**United States Patent and Trademark Office**

**Office Action Summary**

09/418,902

KLEMP ET AL.

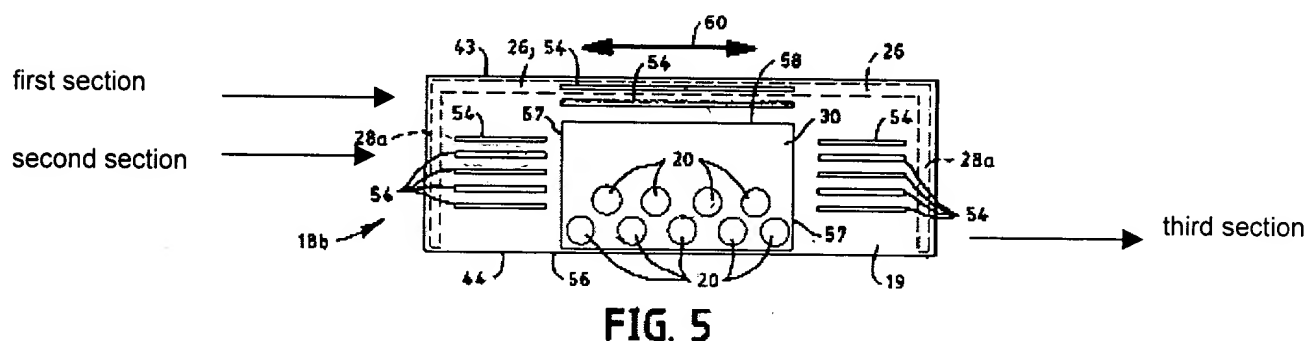
With respect to claim 1, Turner et al (hereinafter referred to as Turner), teaches a disposable absorbent article having side and end edges (10), a topsheet layer (12), a backsheet layer (14), an absorbent core (16), and at least one end strip (18, 19) as shown below:

Turner discloses the first section having generally elastic properties (col. 9, lines 42 – 43), and the second section can be understood to be substantially less elastic than the first section since the second section includes apertures (page 11 of the applicant's specification). Additionally, Turner teaches the third section being spaced away from the topsheet and core as set forth in col. 4, lines 65 – 66.

**FIG. 3**

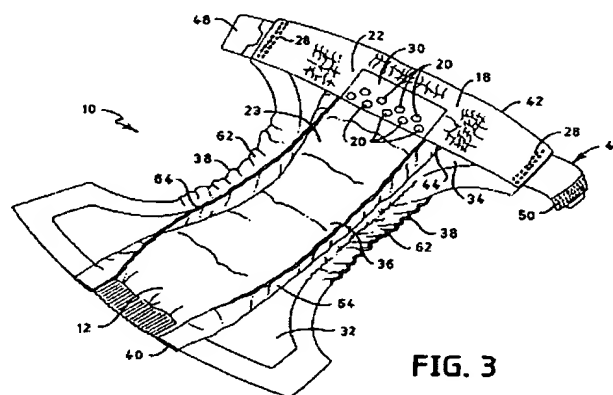
Regarding claim 38, see the rejection of claim 1. Additionally, Turner teaches the containment pocket having a depth dimension (col. 5, lines 19 – 22), with the pocket being disposed generally in the crotch region (figure 6) and being bound by a substantially continuous containment wall which includes the flap portion (18) and the containment flaps (64) providing at least two elastic wall sections and two intermediate wall sections with the intermediate wall sections being generally biased upwards as shown in figure 3.

With respect to claim 39, Turner teaches the end strip (18) to be secured to one of the waist regions including an elastic inward section (third section in the rejection of claim 1) to be spaced away from the topsheet (col. 4, line 65 and figure 3) and forming the elastic wall sections of the containment wall (figure 3).

With reference to claim 40, see the fixed end section is represented by the first and second sections in the drawing incorporated in the rejection of claim 1 since both sections are adhesively joined to the topsheet. This section substantially adjacent one of said end edges as seen in figure 3.

As to claim 42, see figure 3.
